CONSTRUCTION DRAWINGS FOR REX ROAD AT FALCON REGIONAL PARK IMPROVEMENT PLANS

REX ROAD
 AT FALCON REGIONAL PARK
 STREET AND UTILITY PLANS
 COVER SHEET

COUNTY PLAN REVIEW IS PROVIDED ONLY FOR GENERAL CONFORMANCE WITH COUNTY DESIGN CRITERIA. THE COUNTY IS NOT RESPONSIBLE FOR THE ACCURACY AND ADEQUACY OF THE DESIGN, DIMENSIONS, AND/OR ELEVATIONS WHICH SHALL BE CONFIRMED AT THE JOB SITE. THE COUNTY THROUGH THE APPROVAL OF THIS DOCUMENT ASSUMES NO RESPONSIBILITY FOR COMPLETENESS AND/OR ACCURACY OF THIS DOCUMENT.

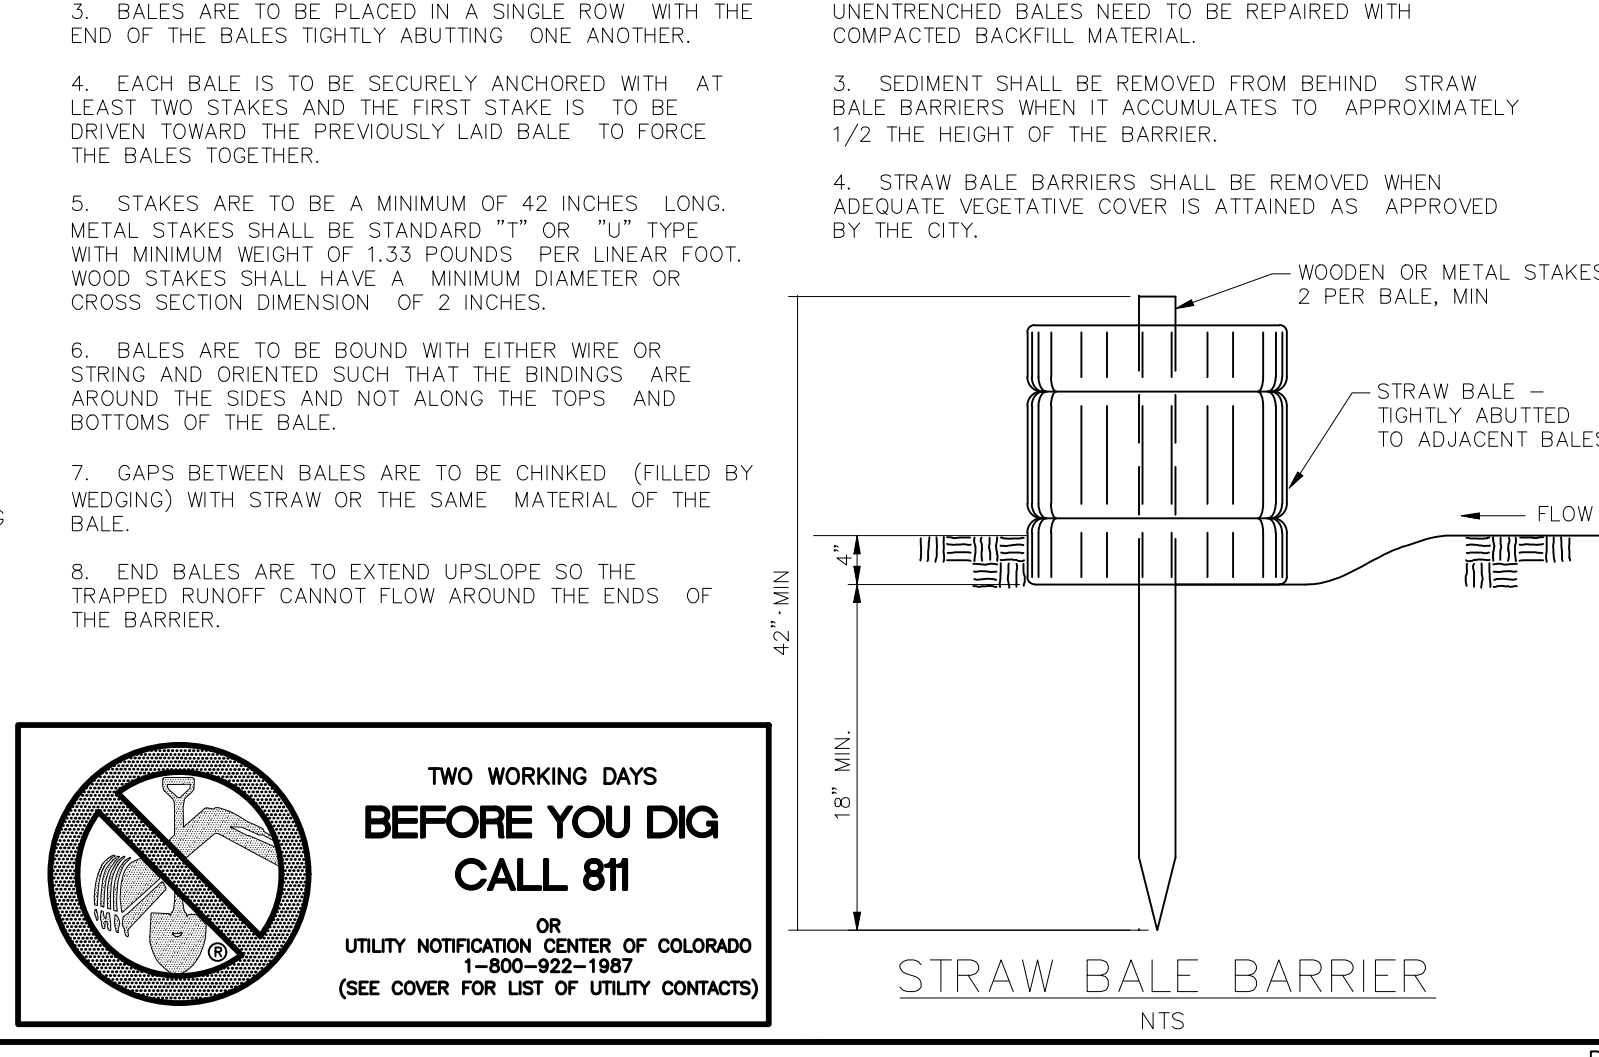
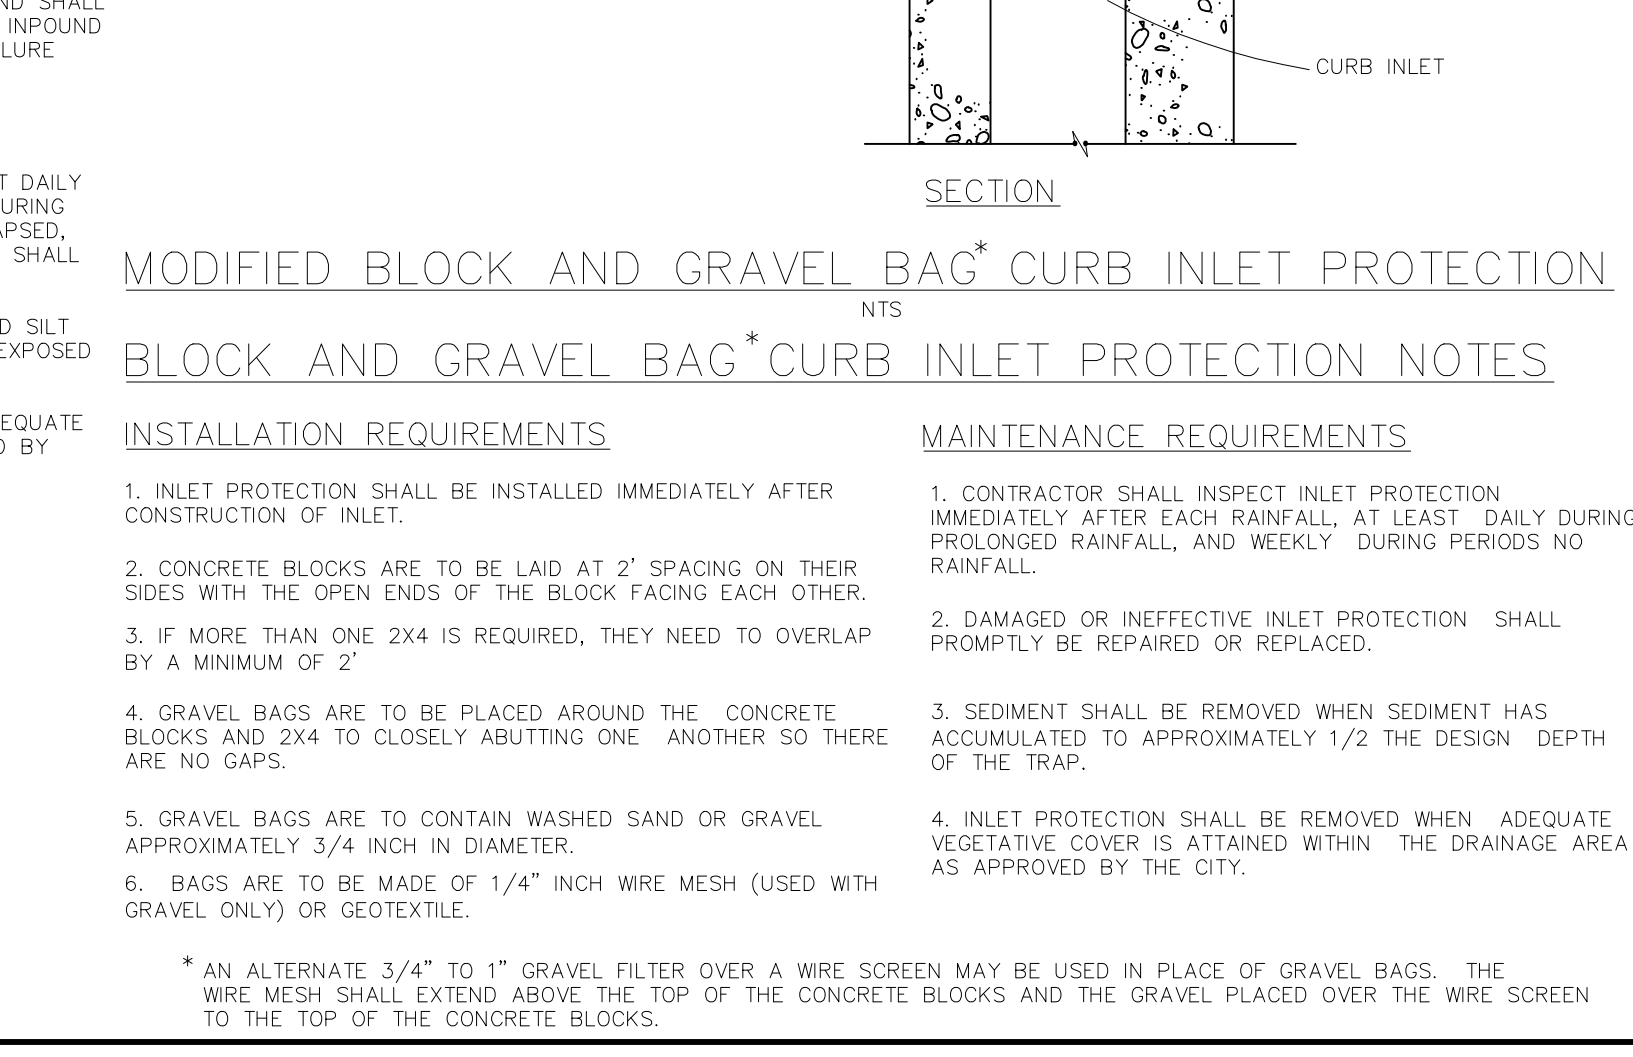
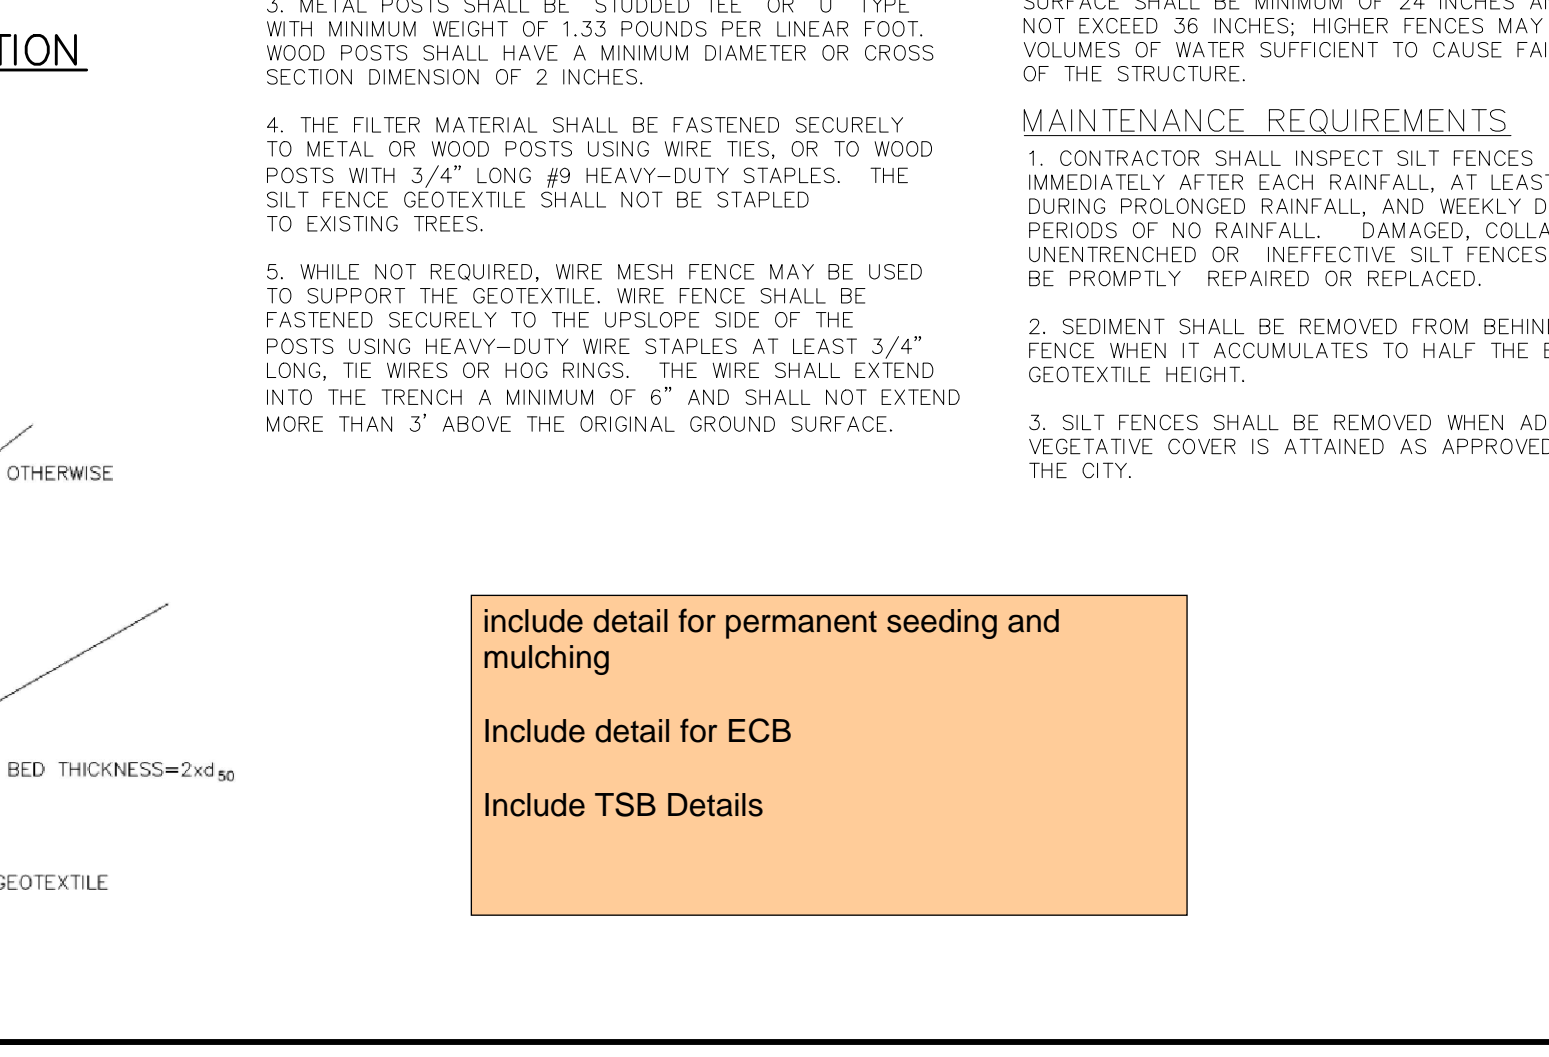
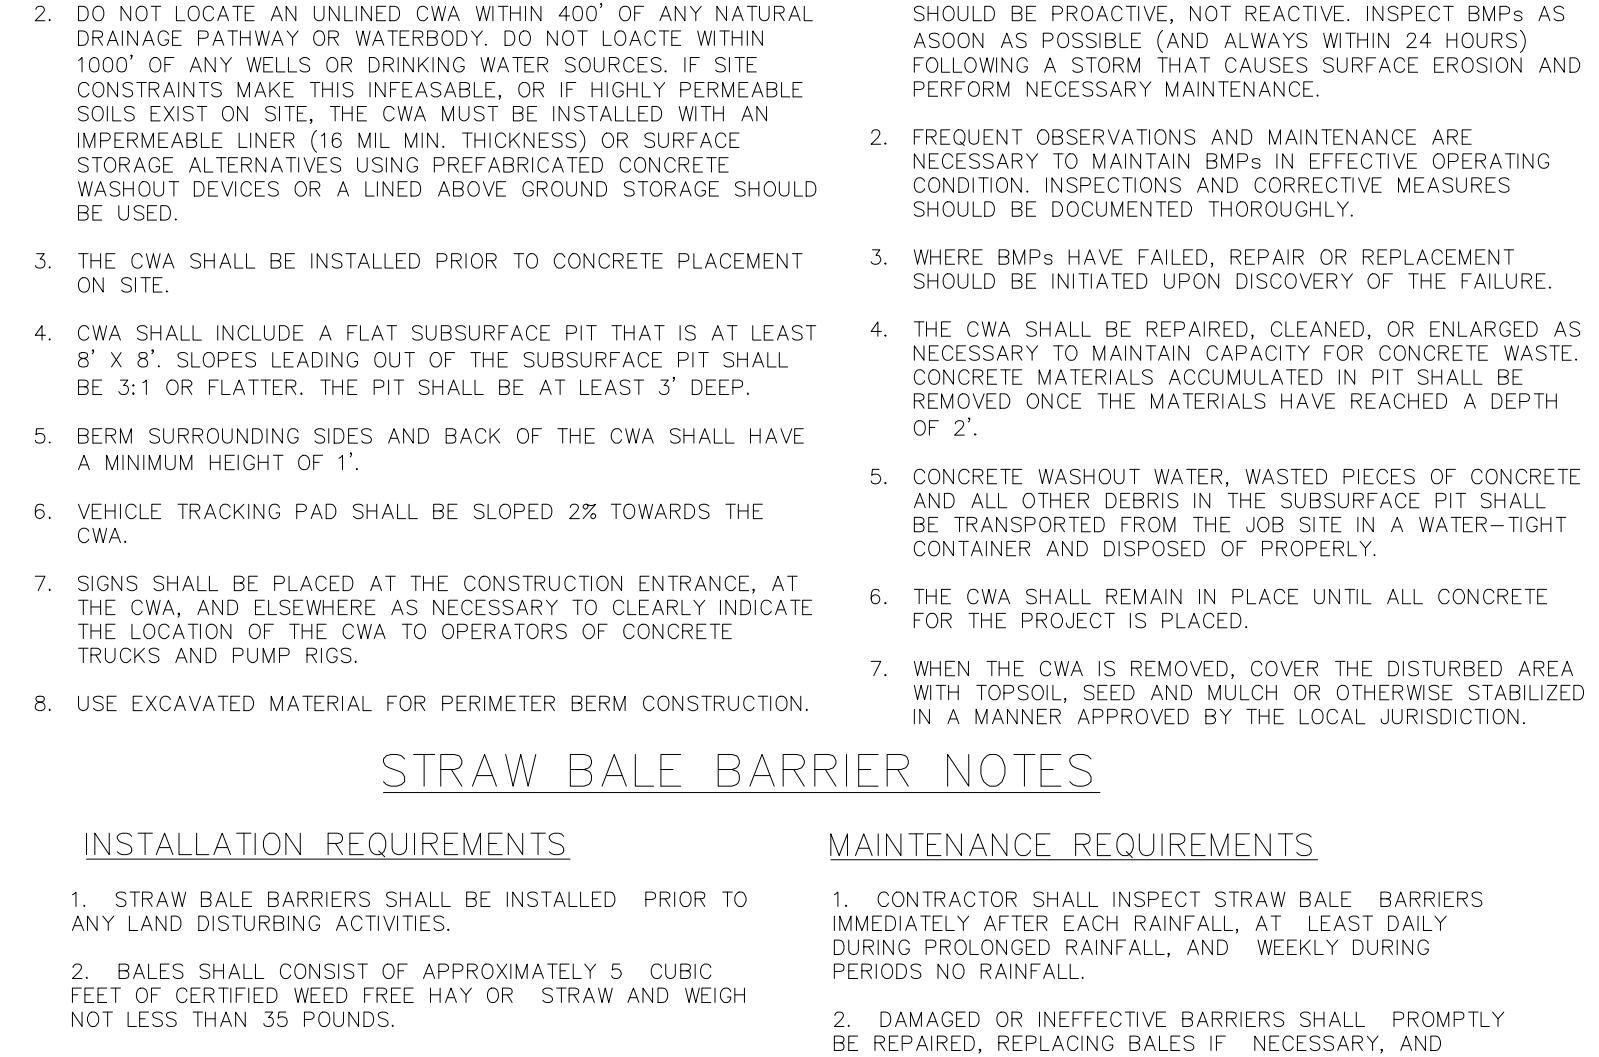
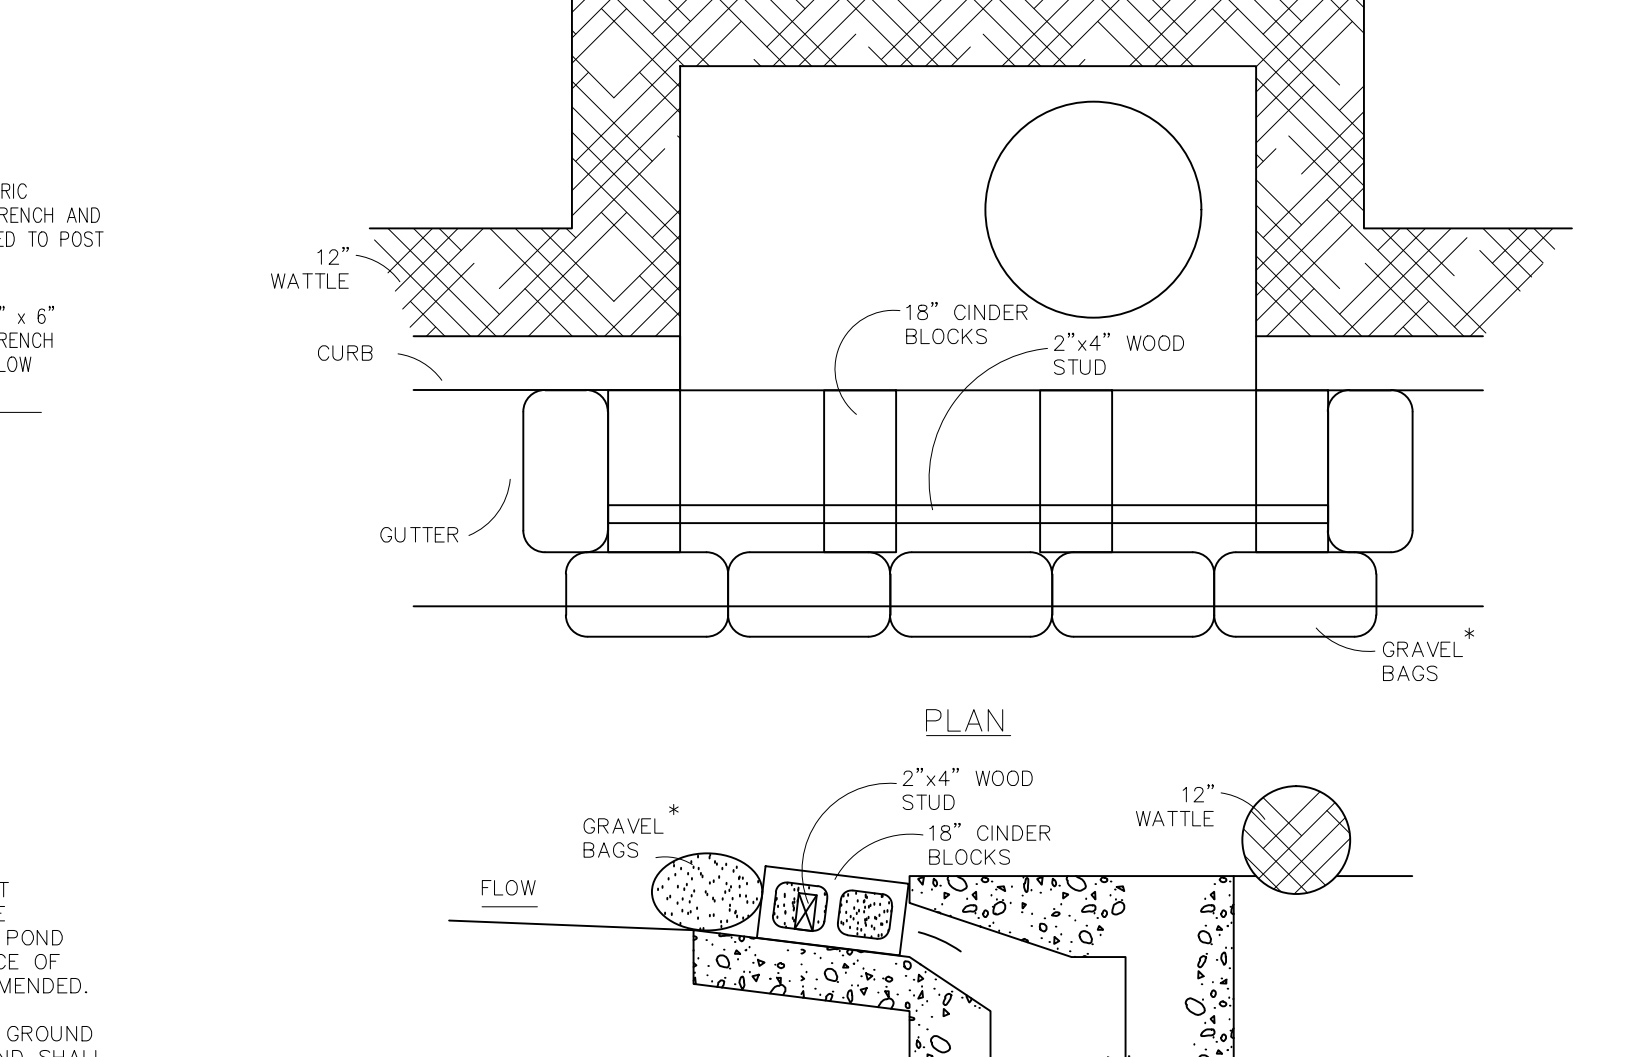
Please also provide typ. cross section of road east of sta 10+00

include detail for permanent seeding and mulching
Include detail for ECB
Include TSB Details
